**Addendum No. 3**  
Page 1 of 21

Joliet Junior College  
1215 Houbolt Road  
Joliet, IL 60431

**TO:** Prospective Respondents  
**SUBJECT:** Addendum No. 3  
**PROJECT NAME:** Renaissance Center Interior Renovations  
**JJC PROJECT NO.:** B16008

A901-01

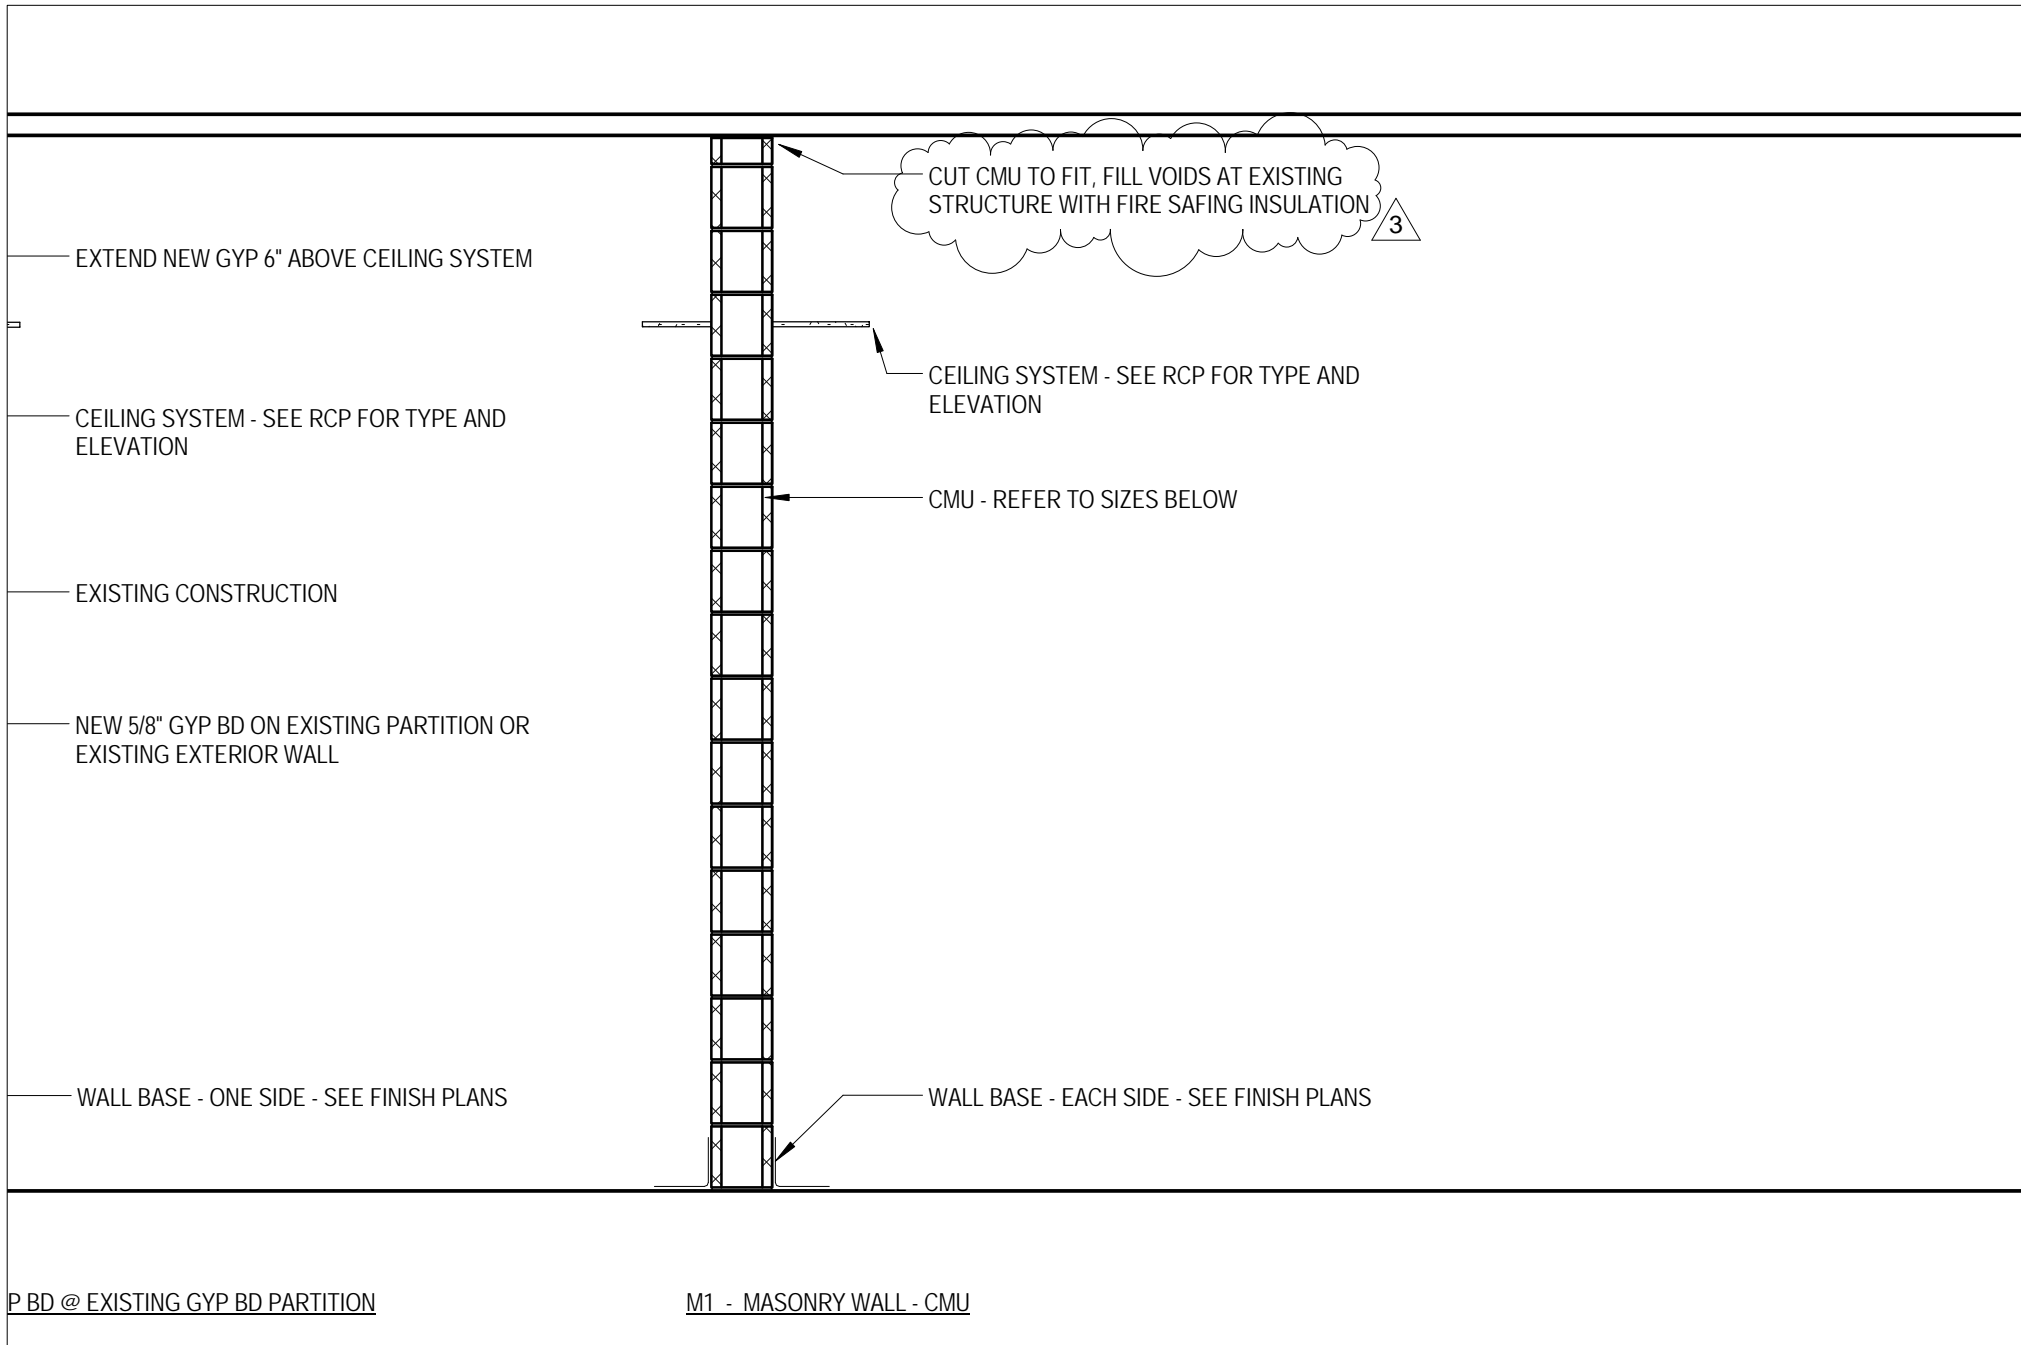
- L. Sheet A7.51: **REVISE** per attached sketches **A751-01 and A751-02**
- M. Sheet A7.52: **REVISE** per attached sketches **A752-01**
- N. Sheet A9.01: **REVISE** per attached sketches **A901-01 and A901-02**
- O. Sheet A10.01: **REVISE** per attached sketch **A1001-01**

AD211-01

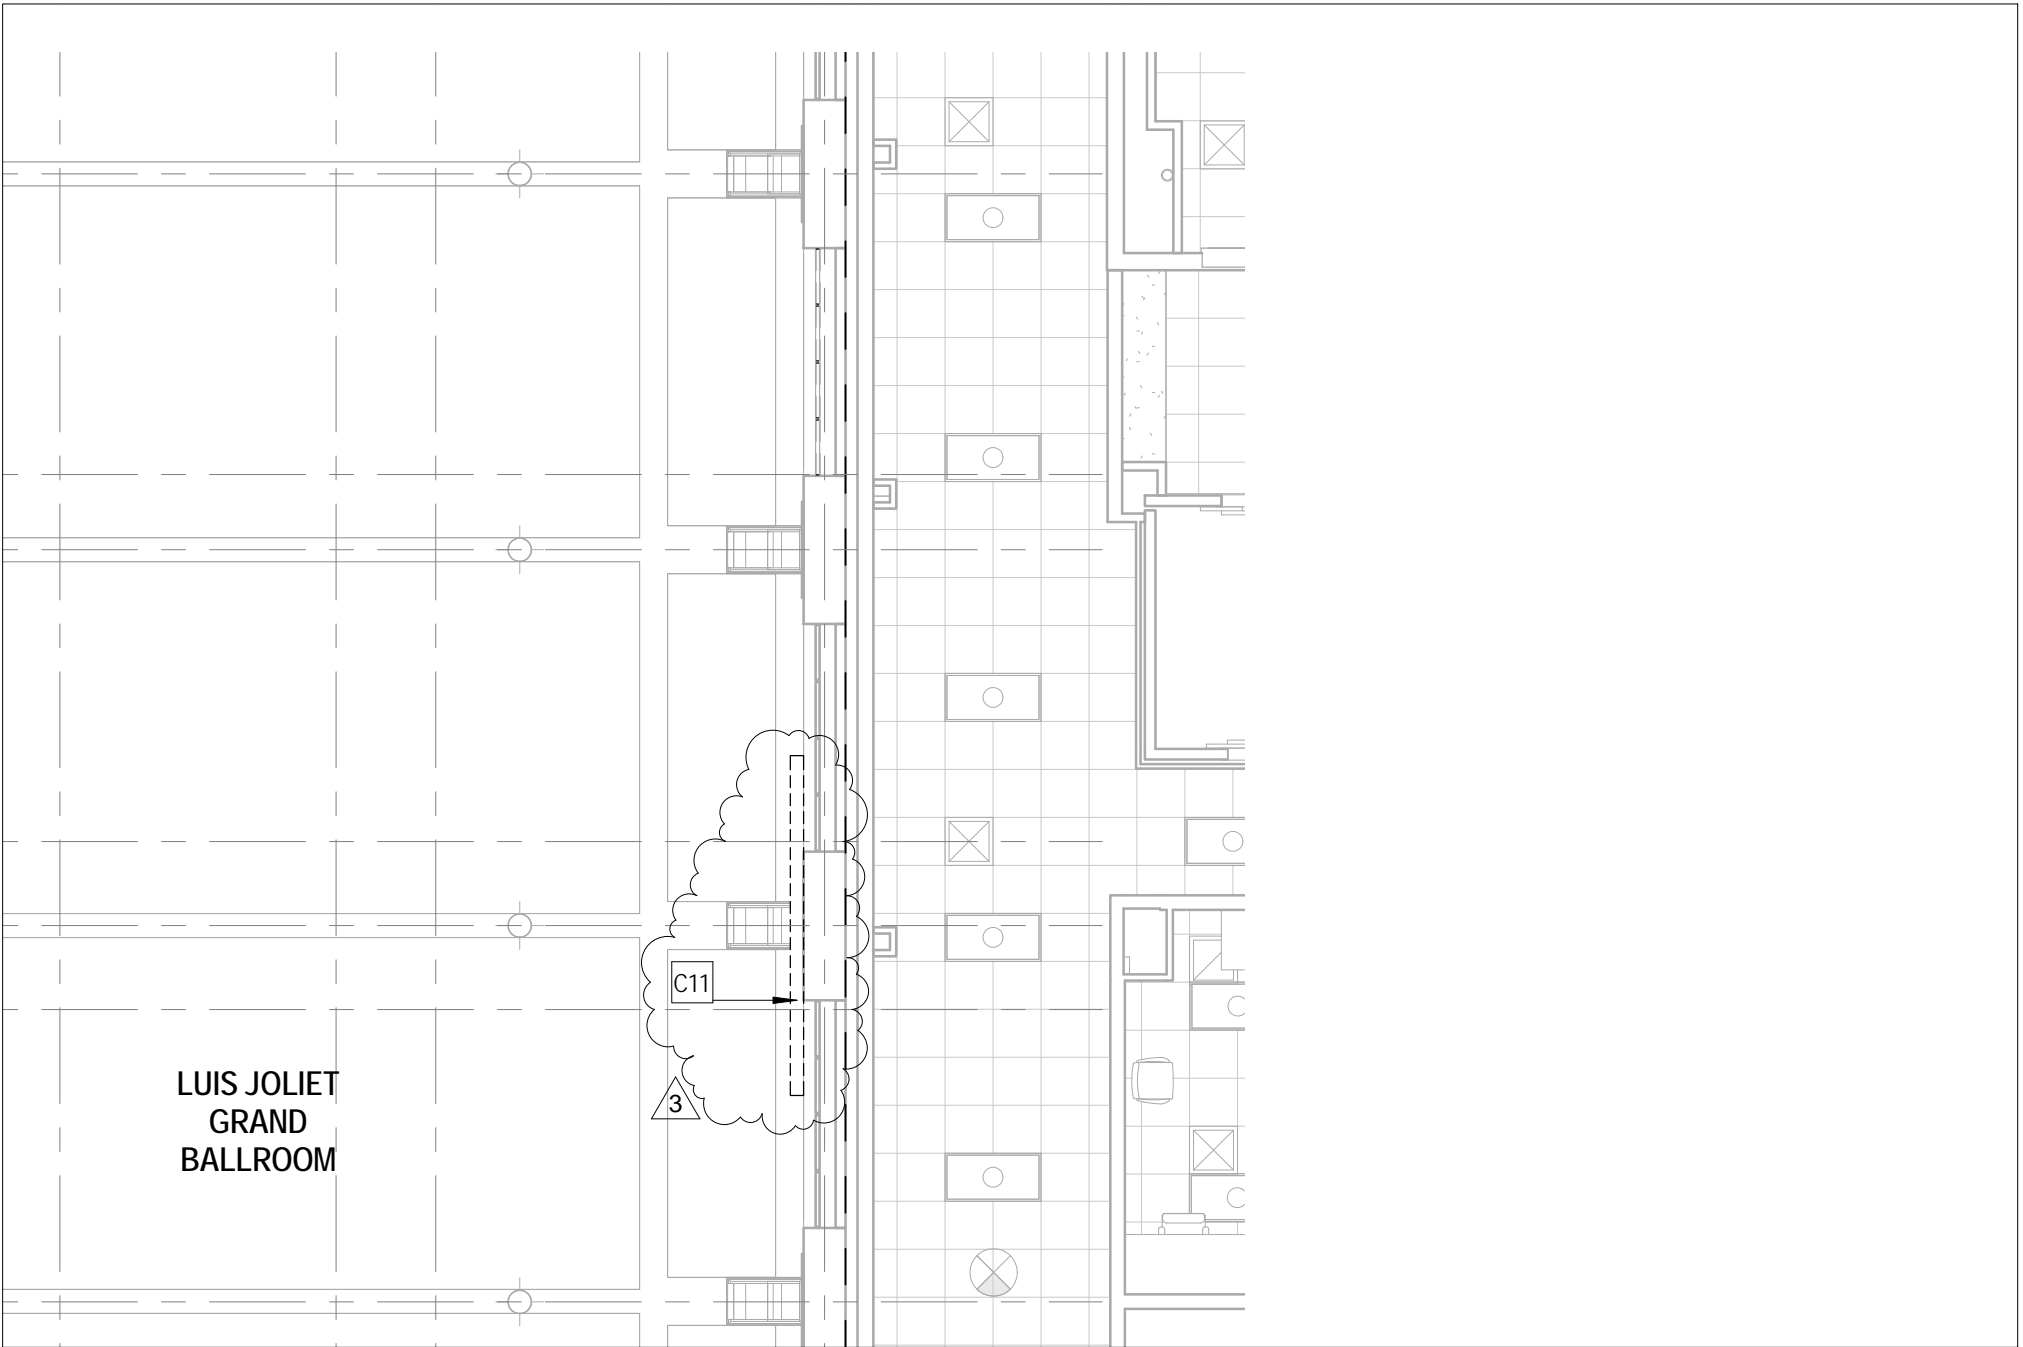
- C. Sheet AD2.11:
- 1) **ADD** keyed note C10 to read "REMOVE PROJECTOR, MOUNT, AND MOTORIZED SCREEN. RETURN TO OWNER."
  - 2) **REVISE** per sketch **AD211-01**
